LAND USE APPLICATION SUMMARY

Property Location: 2707 E 38th Street, 3800-3812 28th Avenue S
Project Name: 38th Street Mixed Use
Prepared By: Kimberly Holien, Principal Planner, (612) 673-2402
Applicant: 3828 LLC, c/o The Lander Group
Project Contact: Tony Kriha
Request: To construct a new four-story, mixed-use building with 53 dwelling units.
Required Applications:

VARIANCE #2: SOUTHEAST CORNER OF EAST FRONT YARD SETBACK ADJACENT TO R1A ZONING

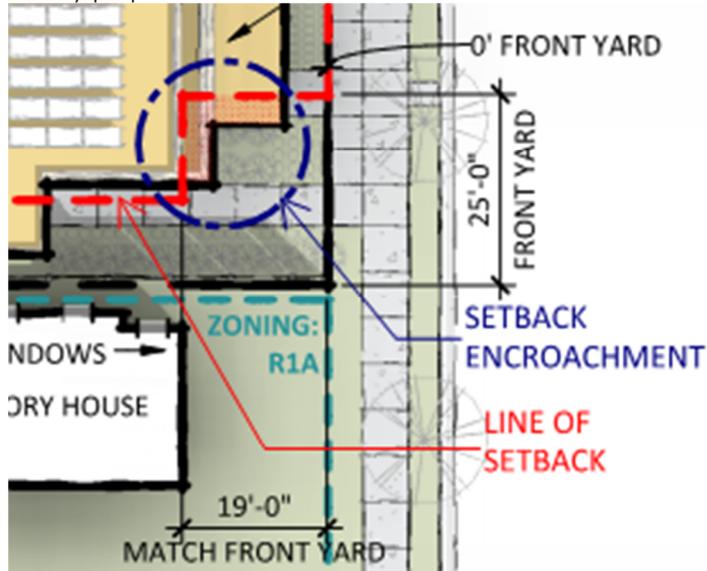
1. Practical Difficulties: In order to maintain the desired look and composition of the front façade and maximize the extern of the frontyard, the 2-story walk-up balcony and building corner encroach 48-inches into the setback.

2. Use of Property keeping with spirit and intent of ordinance: The remaining portion of the site to the north does not require a setback so the encroachment allows the design to be located further into the site along the entire length which allows more landscaping and reduces the building scale along the front of the building.
3. This variance will not alter the essential character of the locality as it allows the façade design to better meet the look of the district by keeping the proportions and composition simplified and maximize the extent of the frontyard. It is not detrimental to the health, safety, or welfare of the general public or those using the property or nearby properties.

VARIANCE #4: REDUCE 28TH STREET MAX SETBACK

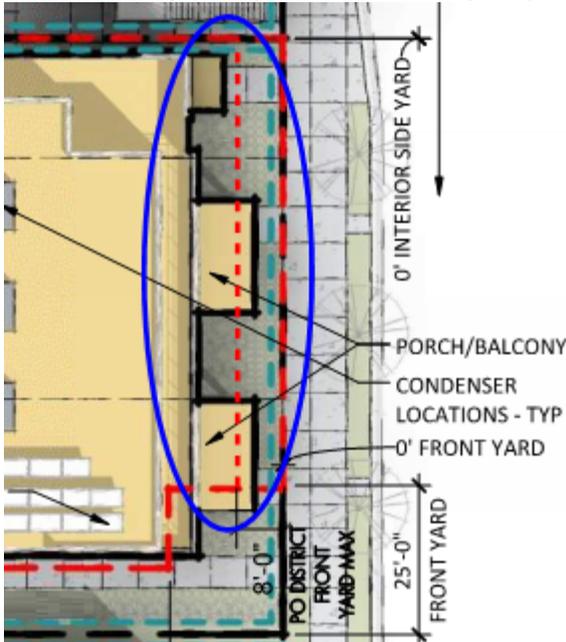
1. Practical Difficulties: There are two setback requirements along 28th Street – one in the standard zoning requirements and one per the Pedestrian Overlay (PO) 551.110 Building placement requirements. While the standard zoning would allow zero setback along, the PO requirements indicate a maximum setback of eight feet. Staff has noted that there is a policy clarification in the works to address this conflict to have the zoning requirement override the PO requirement.
2. Use of Property keeping with spirit and intent of ordinance: The intent of the design is to provide interaction with the building and site elements which does occur thru use of porches, while creating interest.
3. This variance will not alter the essential character of the locality. It is not detrimental to the health, safety, or welfare of the general public or those using the property or nearby properties.

VARIANCE #5: PARKING INTO REARYEARD SETBACK

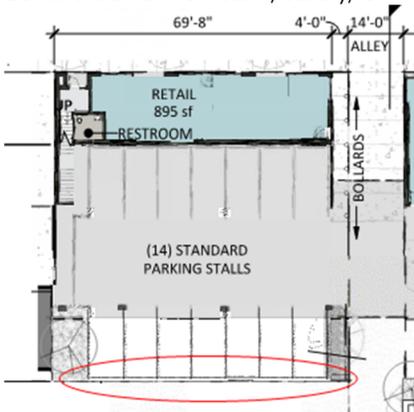
1. Practical Difficulties: Locating the parking in the 11'-0" rearyard parking setback allows for full size parking stalls and relocation of the dumpster area away from residential garage. There is also the possibility of climbing landscape at the fence as a landscape buffer.
2. Use of Property keeping with spirit and intent of ordinance: The variance will allow parking on the site to be increased and allows the design to be located further into the site which allows more landscaping at the south rearyard lotline.
3. This variance will not alter the essential character of the locality, as it allows for maximum stall size. It is not detrimental to the health, safety, or welfare of the general public or those using the property or nearby properties.

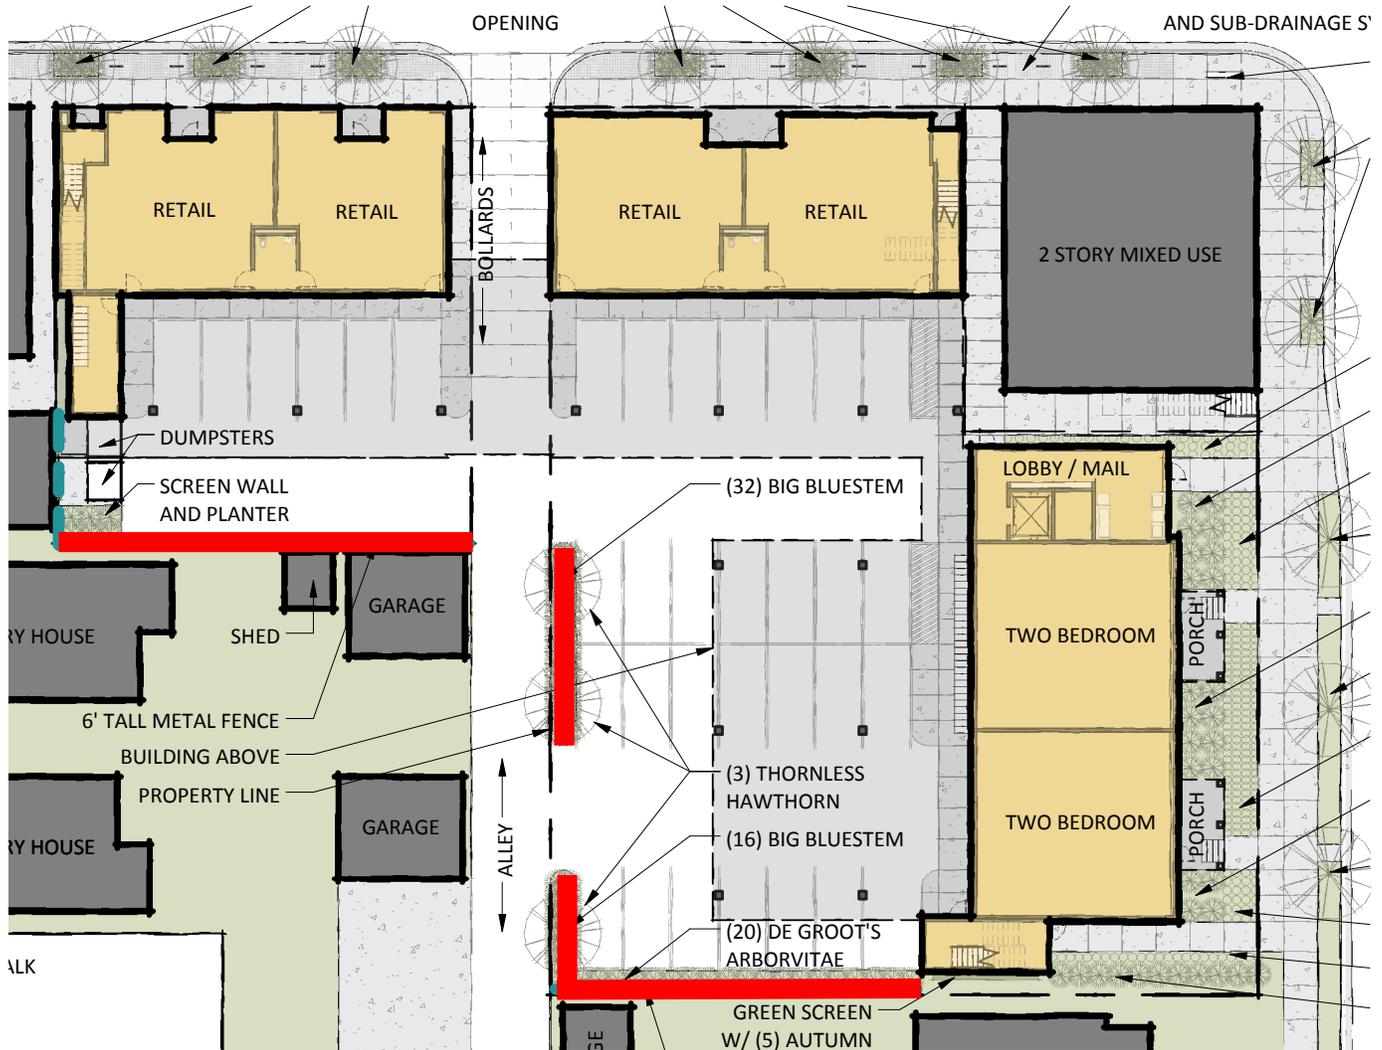
The 3800 Mixed Use project is requesting alternate compliance for the landscape buffer between parking and adjacent residential. The proposed alternate compliance, at locations shown on site plan and indicated in red below, will be accomplished by six foot tall hedge with periodic trees planted on our property or in concert with adjacent property owners. This planted buffer can be accomplished in less than 7'-0" and provides an edge more desirable than a fence.

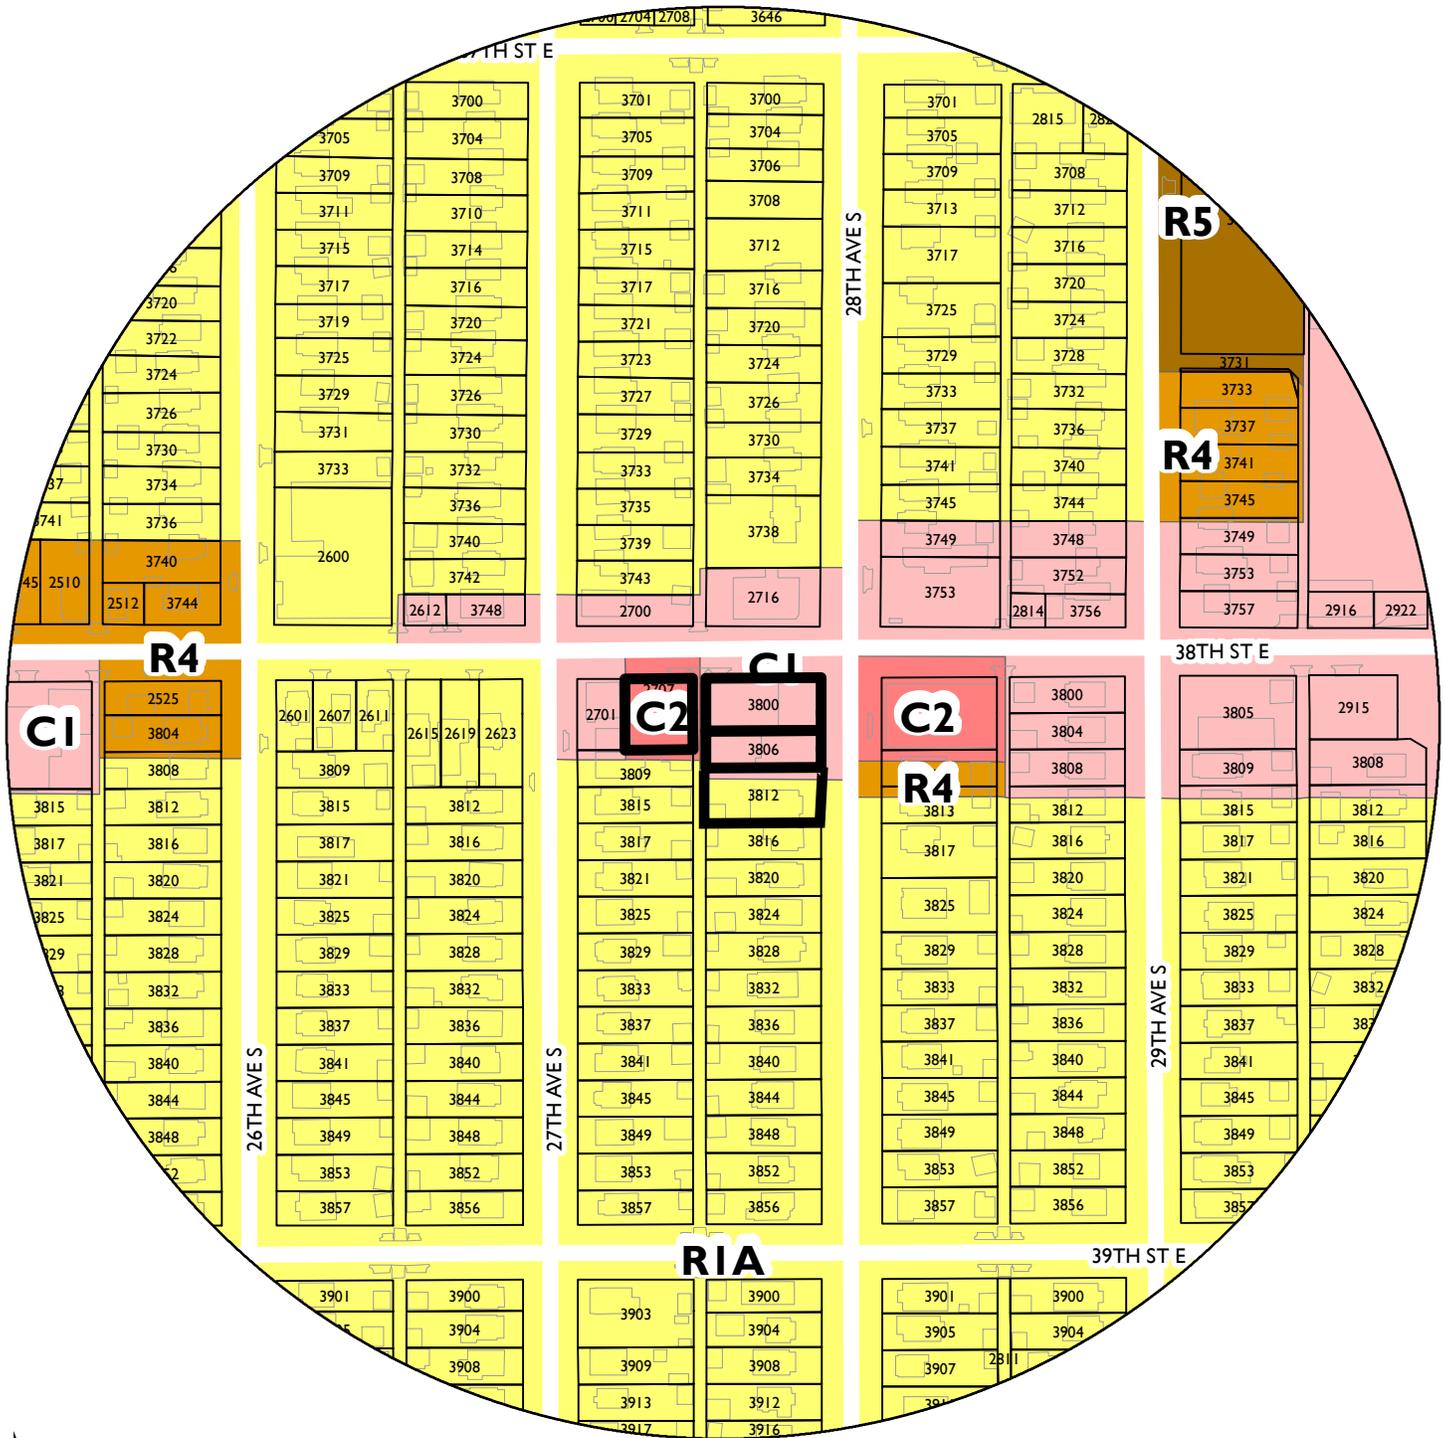
- The connecting link over and across the property lines may require special approvals from the building official and additional documentation.
- Roof top mechanical equipment and solar panels less than 10' to roof edge will require guards per IBC 1013.6
